City of Portland, Maine – Building or Use Permit Application 389 Congress Street, 04101, Tel: (207) 874-8703, FAX: 874-8716

REASON FOR PERMIT: Change of use from 2 to 3 units with New Stairtower

RE: 92 East Kidder St. change of use permit

92 E. Kidder St plot plan

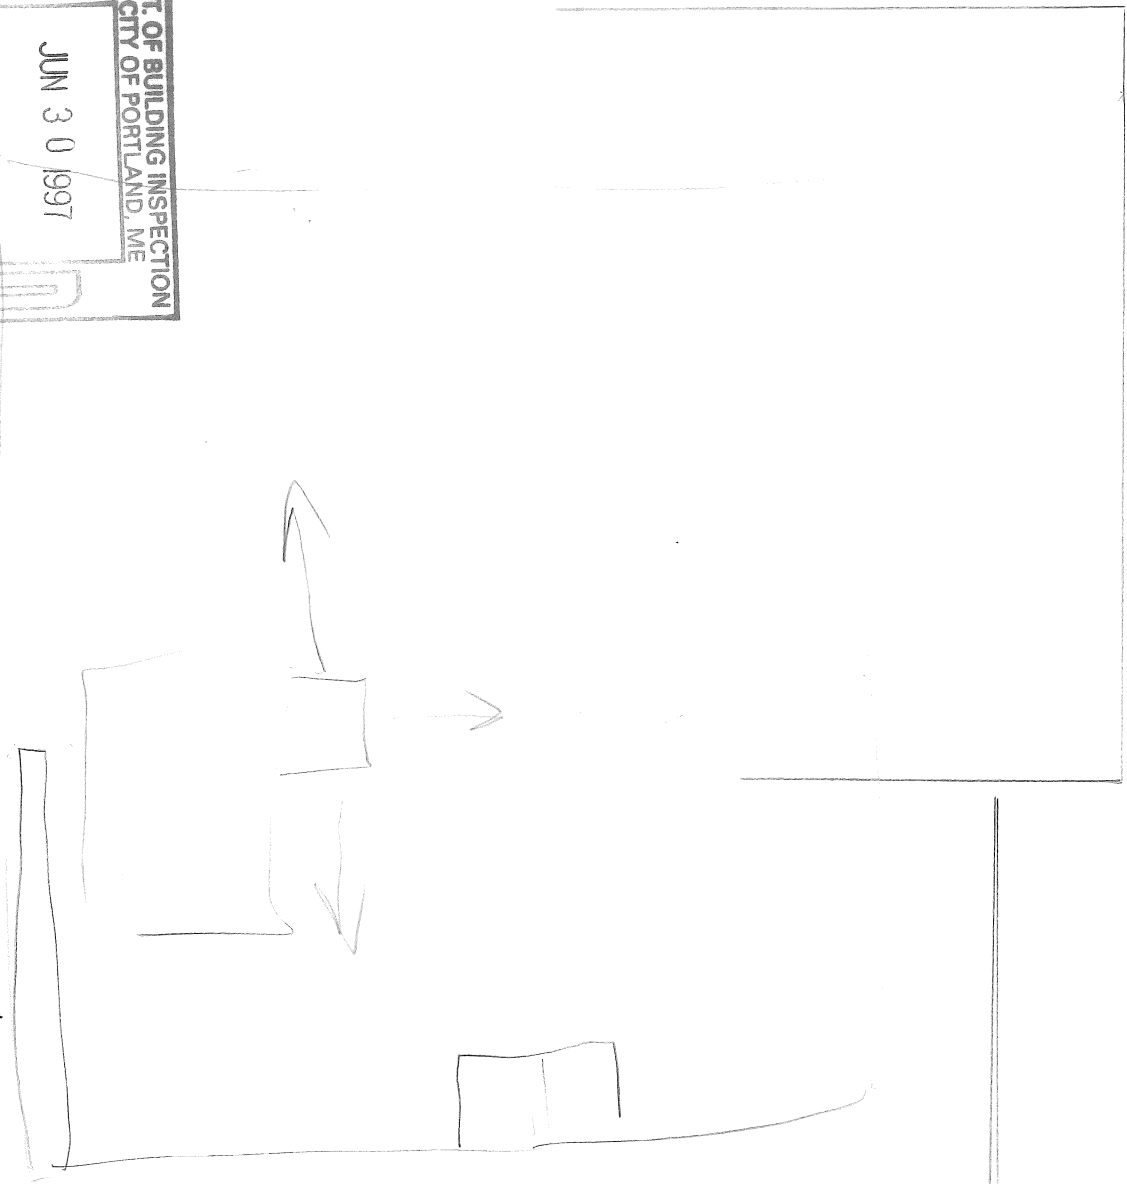
Front Yard - 20' req - 20' + shown

Rear Yard - 20' req - 50' + shown

Side Yard - 14' req 50' + shown

OK Needs 600 sq ft
Shows 20' x 30' = 600 sq ft

Off-street Parking - ^{1 space exist} _{1 1/2 for new unit} = 2 1/2 3 1/2 req - 6 spaces shown

92 E Kidd St. Proposed stair tower.

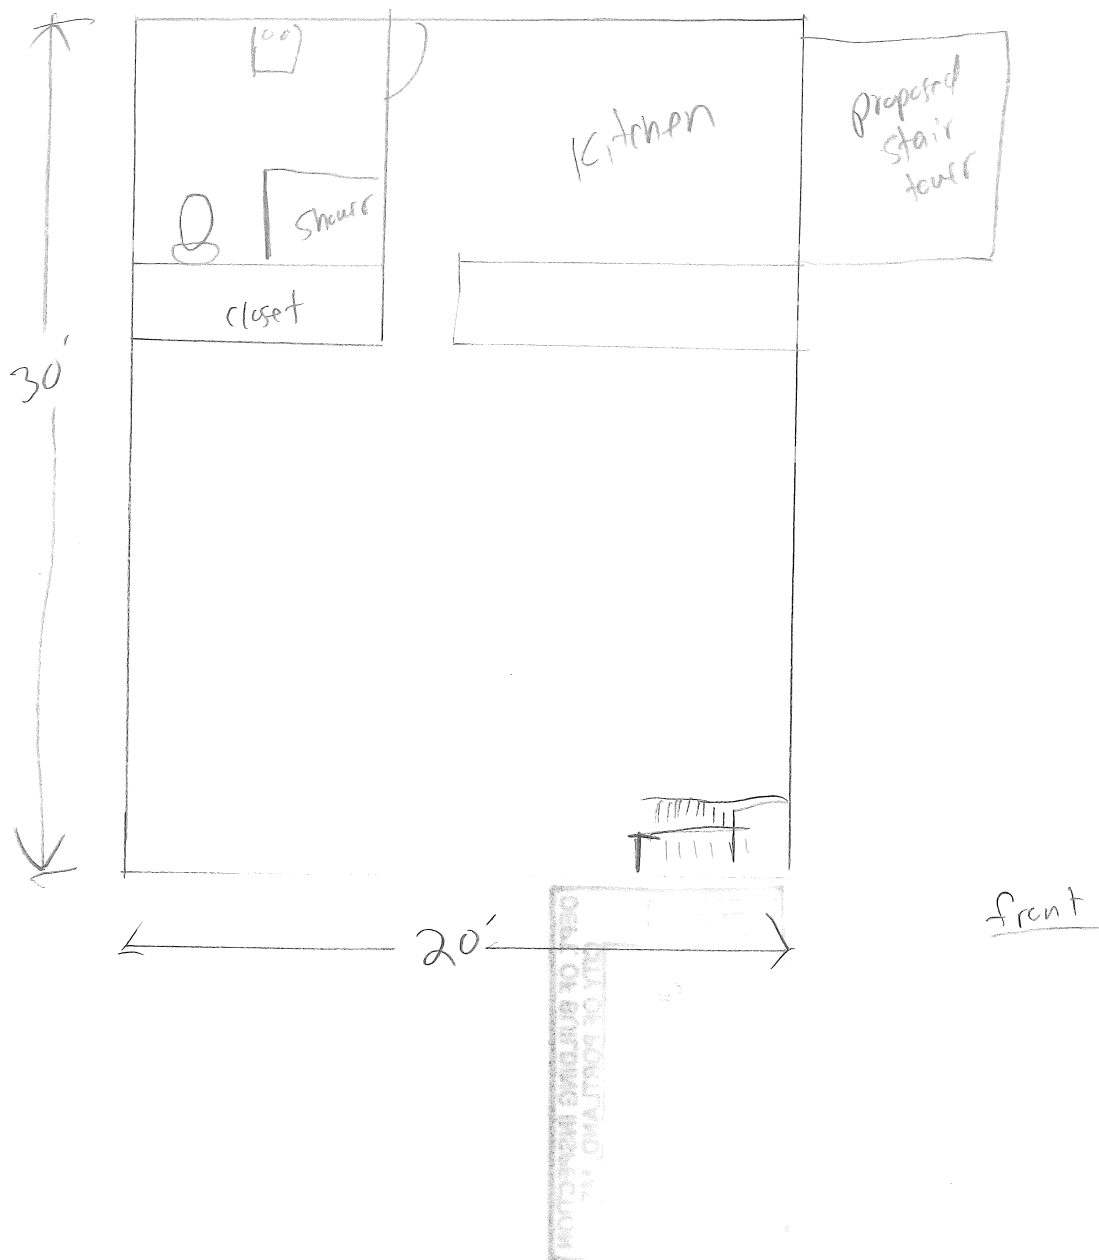
Height - ^{max req} → No higher than 35' req - plans not specific.

9. Other requirements of condition The New enclosed Stairtower shall be no higher than 35 feet which is the MAXIMUM in this zone.
